CHERRY CREEK CROSSING, FILING NO. 1 LOT 111

OVERLOT GRADING & EROSION CONTROL PLAN

PCD PROJECT NO. CDR-17-003

Project No.:	14028
Date:	SEPT. 20, 2017
Design:	RNW
Drawn:	EAK
Check:	RNW
Revisions:

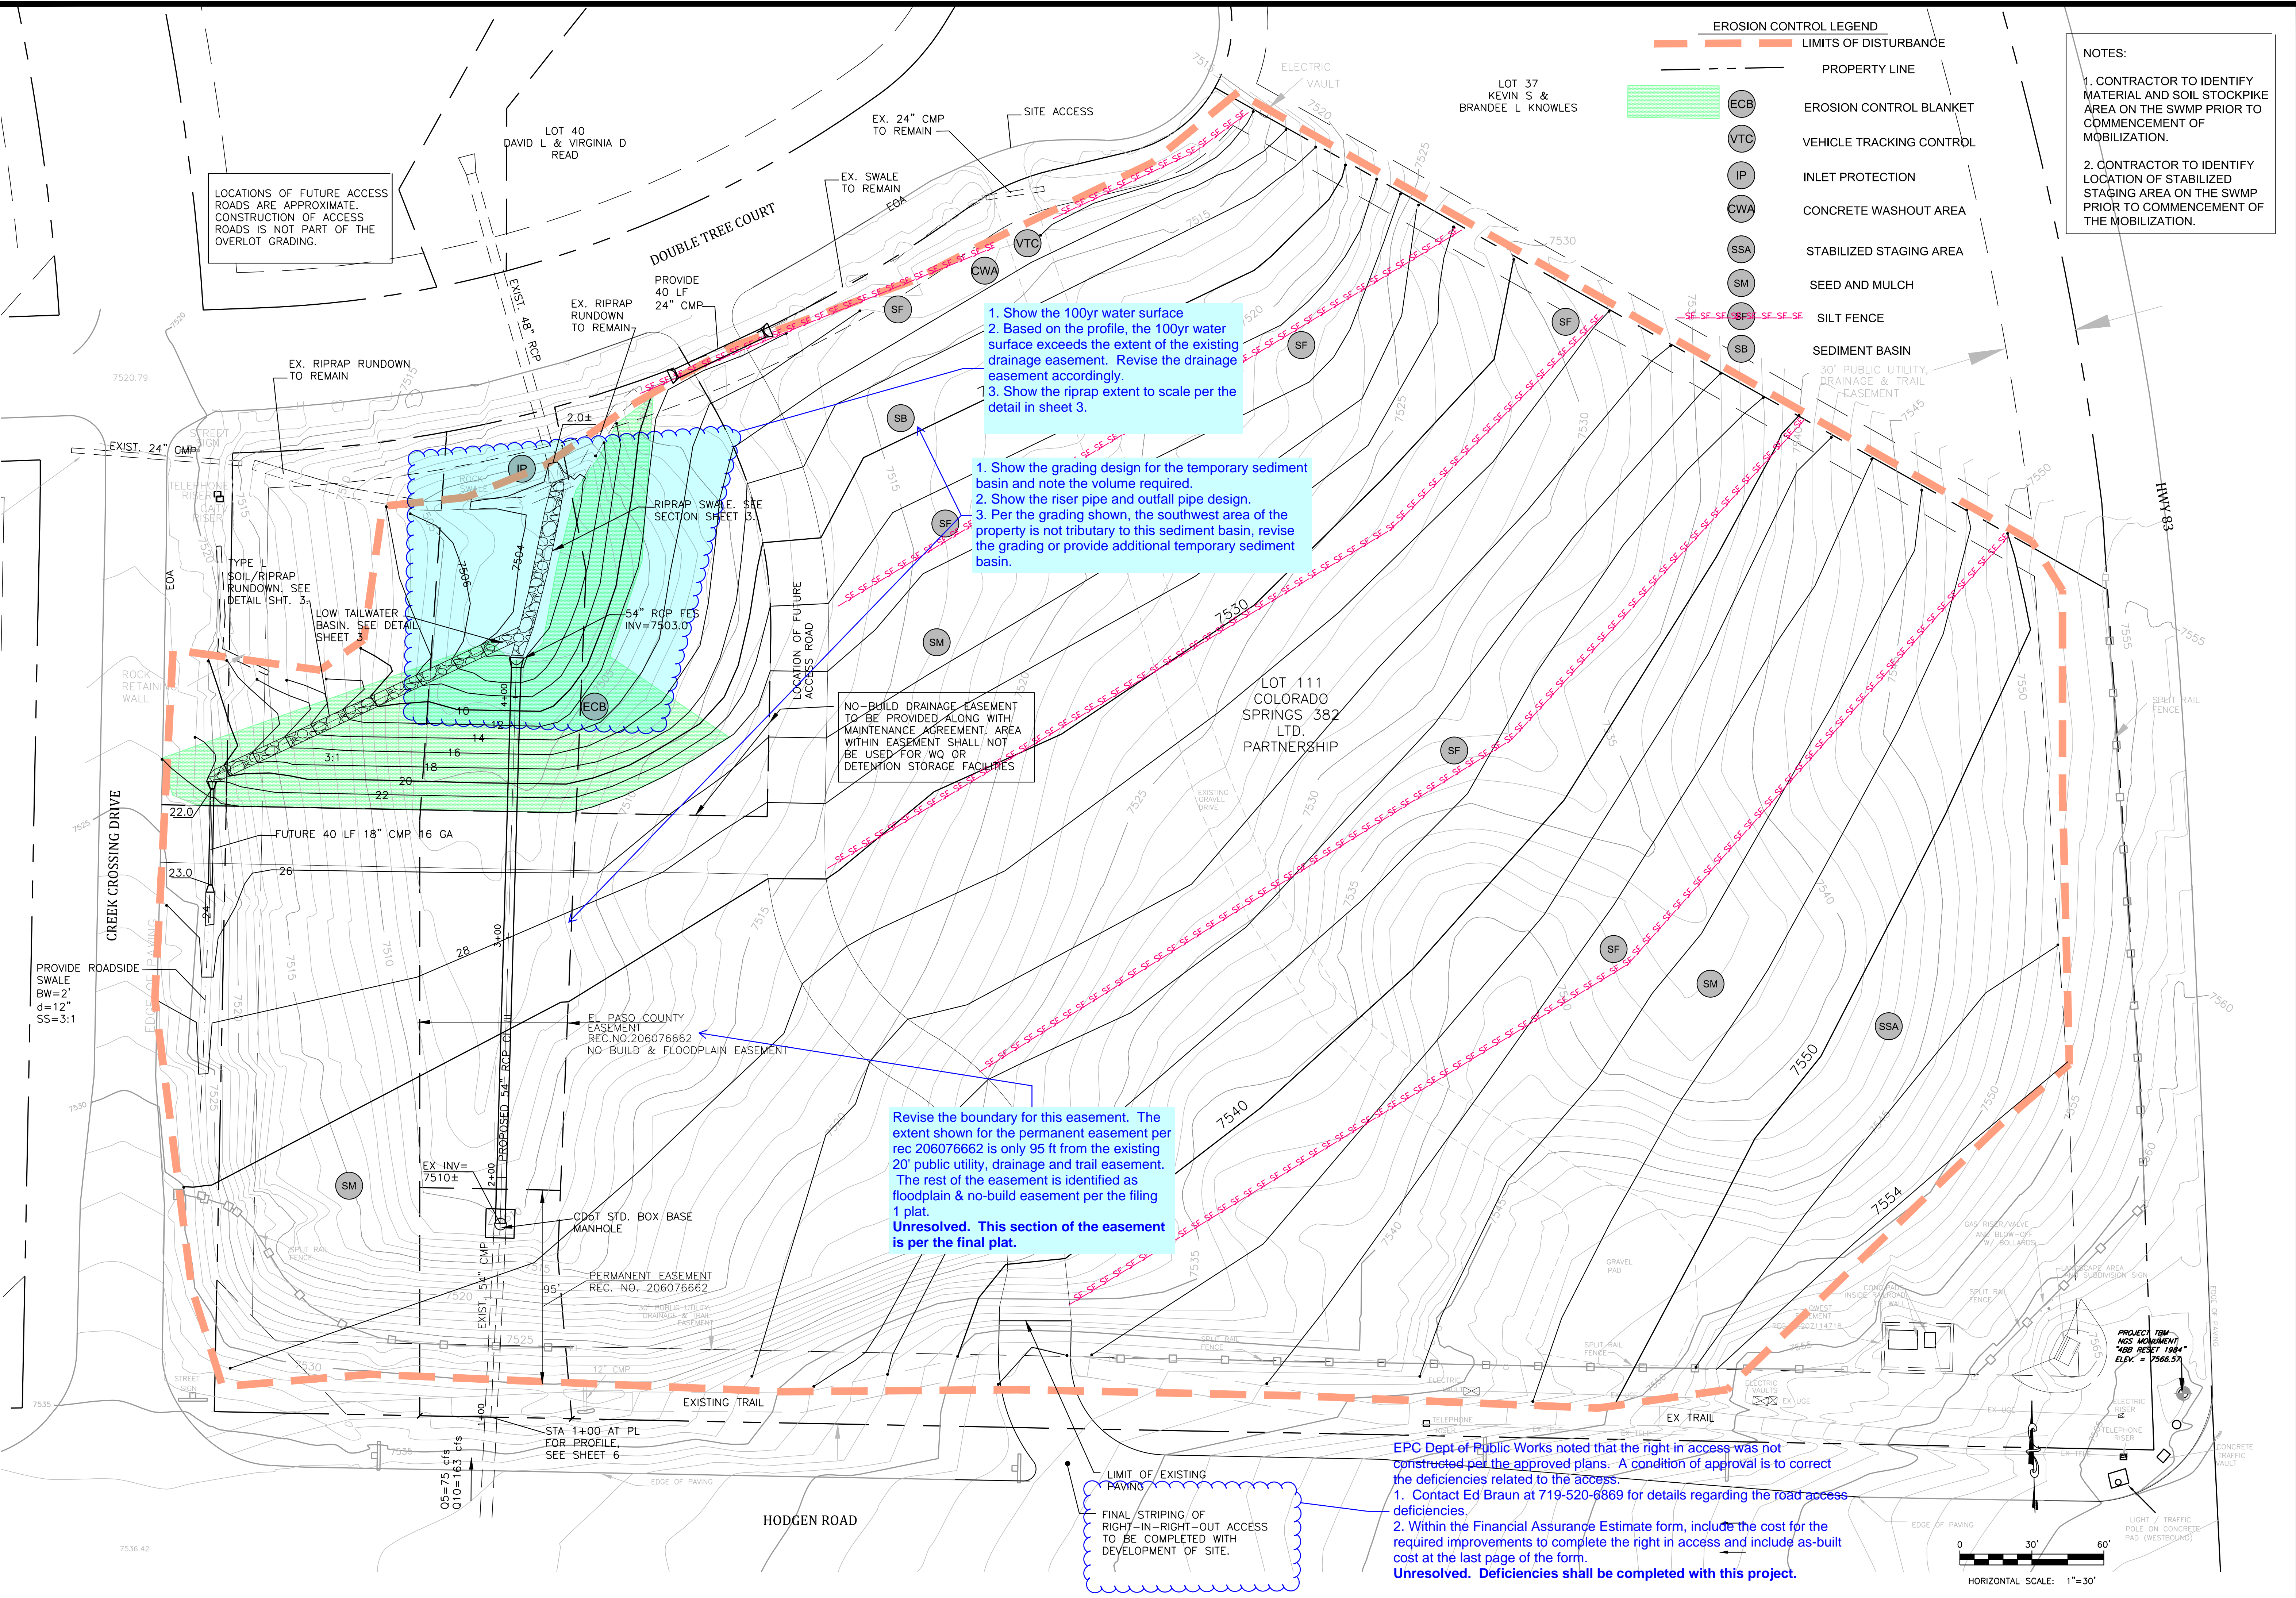
1. Show the 100yr water surface
2. Based on the profile, the 100yr water surface exceeds the extent of the existing drainage easement. Revise the drainage easement accordingly.
3. Show the riprap extent to scale per the detail in sheet 3.

1. Show the grading design for the temporary sediment basin and note the volume required.
2. Show the riser pipe and outfall pipe design.
3. Per the grading shown, the southwest area of the property is not tributary to this sediment basin, revise the grading or provide additional temporary sediment basin.

Revise the boundary for this easement. The extent shown for the permanent easement per rec 206076662 is only 95 ft from the existing 20' public utility, drainage and trail easement. The rest of the easement is identified as floodplain & no-build easement per the filing 1 plat.
Unresolved. This section of the easement is per the final plat.

EPC Dept of Public Works noted that the right in access was not constructed per the approved plans. A condition of approval is to correct the deficiencies related to the access.
1. Contact Ed Braun at 719-520-6869 for details regarding the road access deficiencies.
2. Within the Financial Assurance Estimate form, include the cost for the required improvements to complete the right in access and include as-built cost at the last page of the form.
Unresolved. Deficiencies shall be completed with this project.

STANDARD EPC GRADING AND EROSION CONTROL NOTES

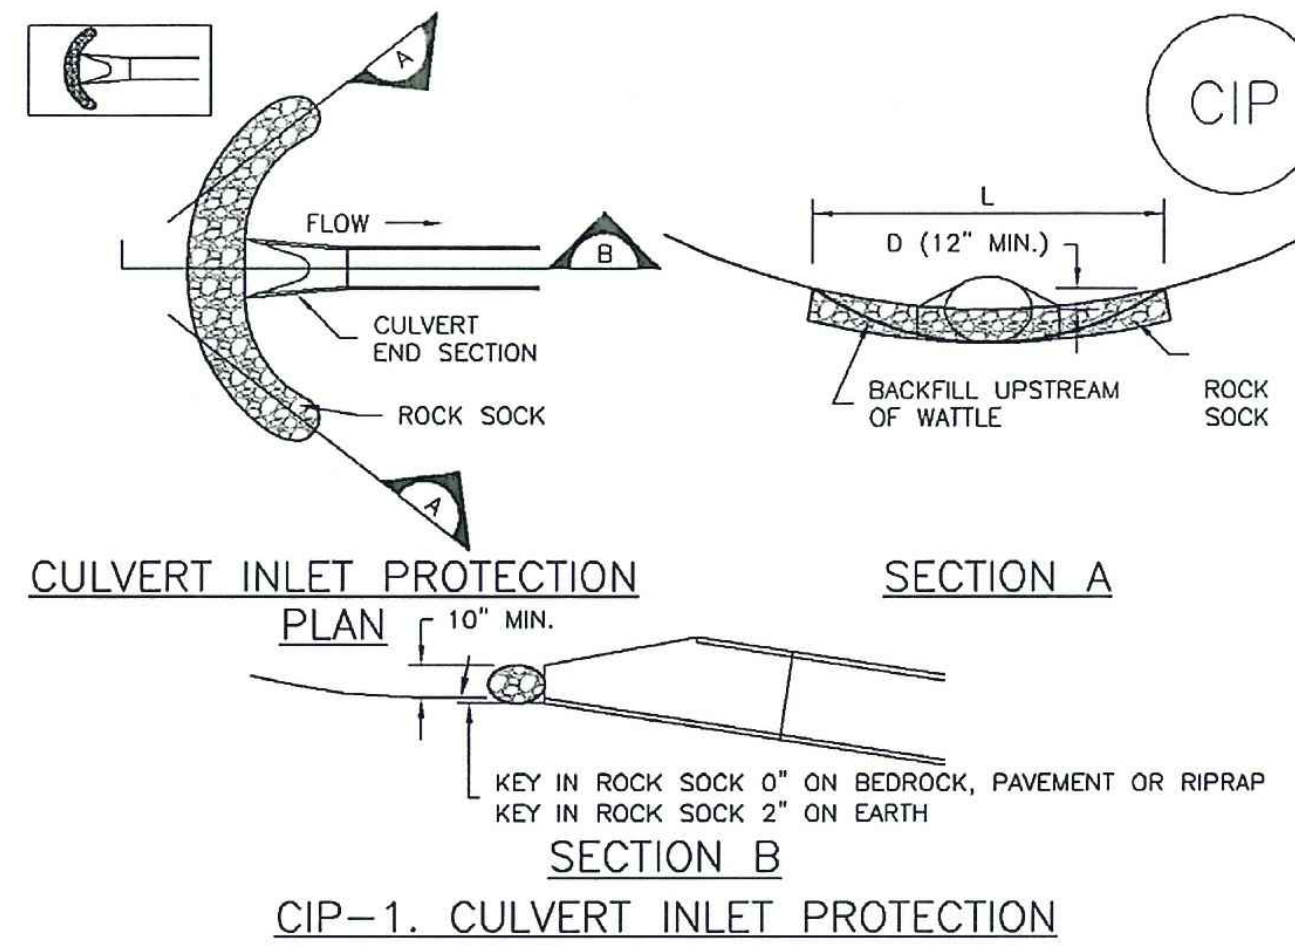
Insert the following standard GEC note as #26 and renumber the current note as #27: The soils report for this site has been prepared by _____ and shall be considered a part of these plans.

Change to #27

Sediment Basin (SB)

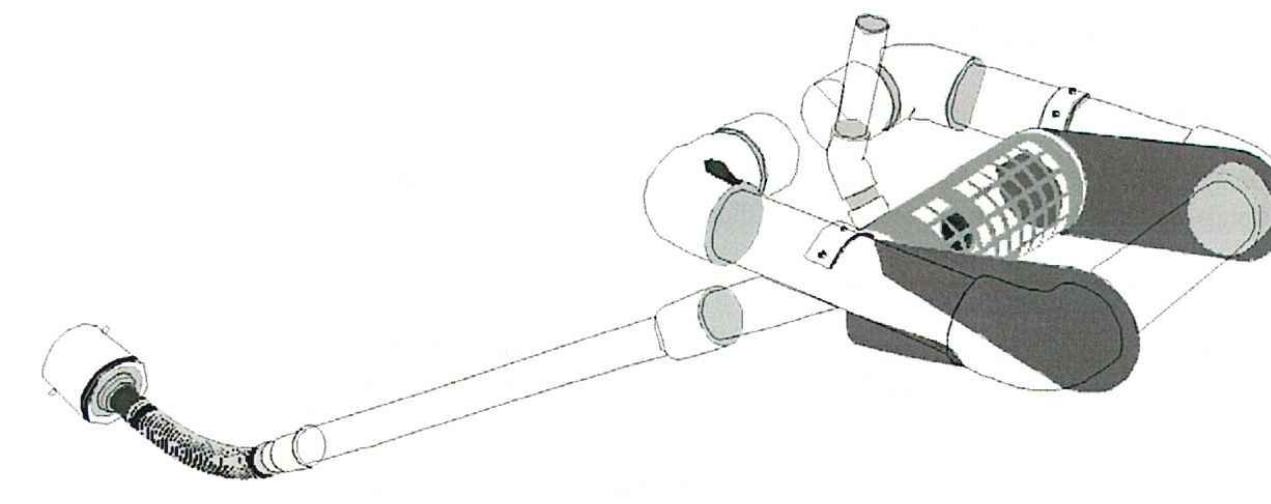
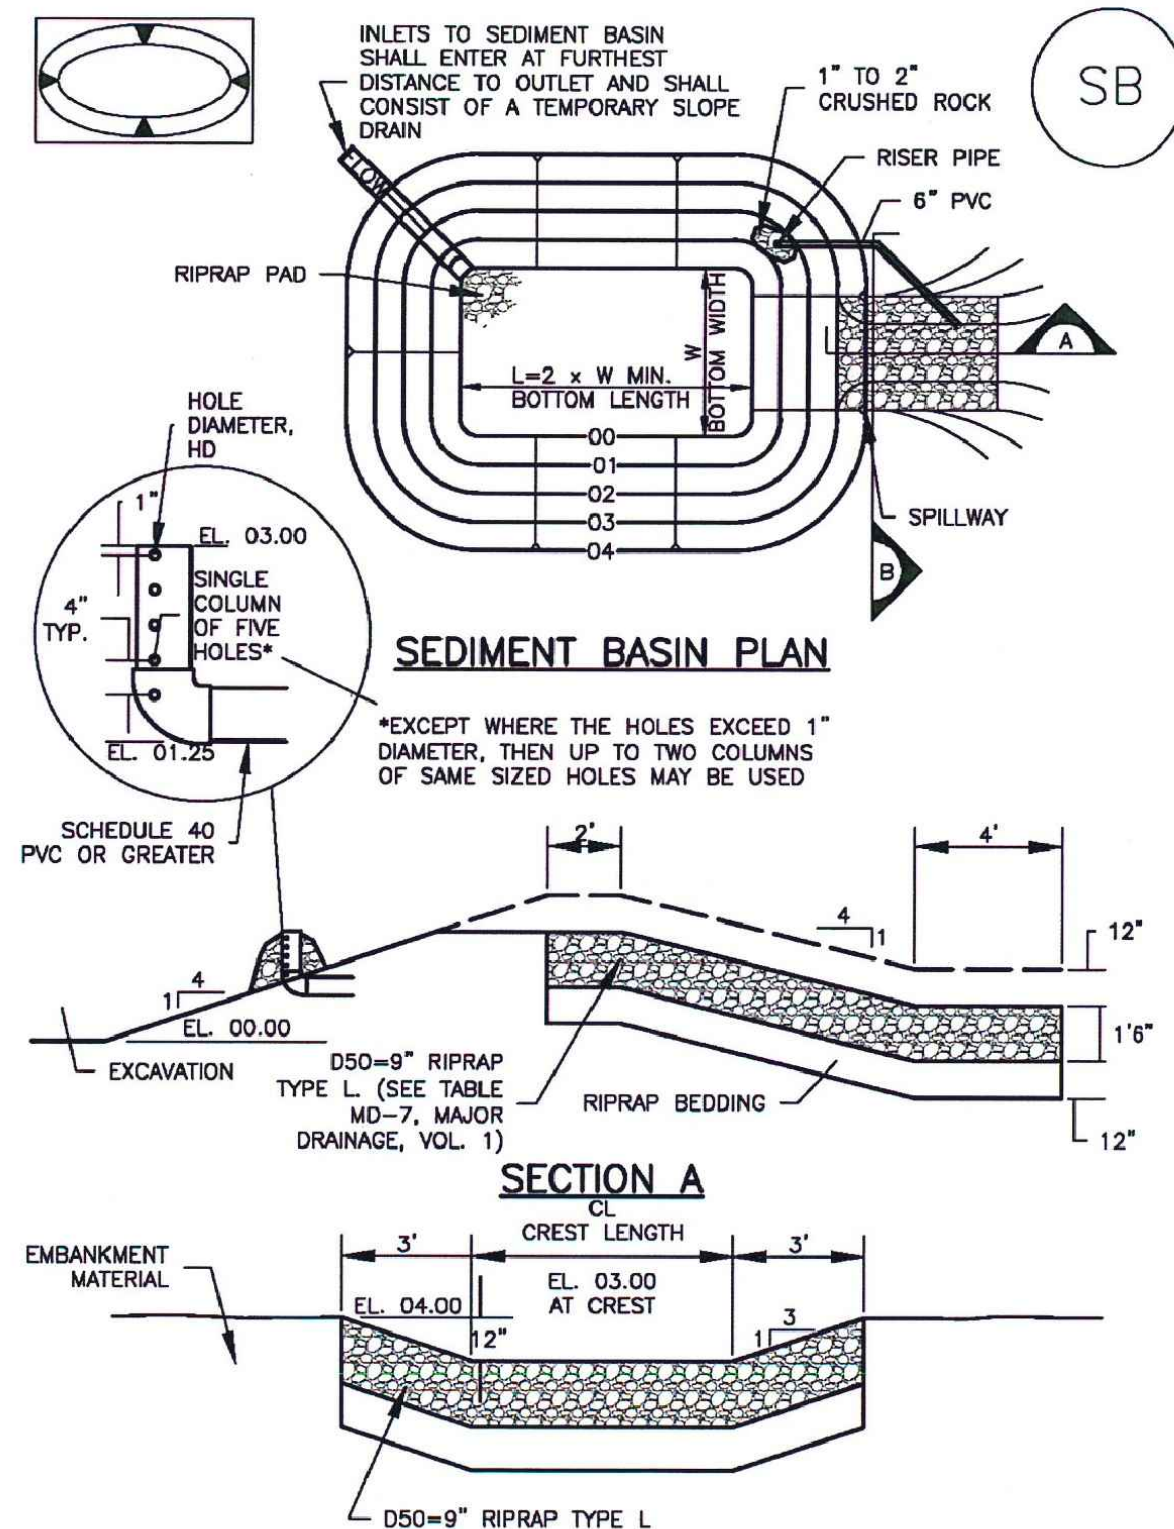
Remove. Riser pipe shall be used.
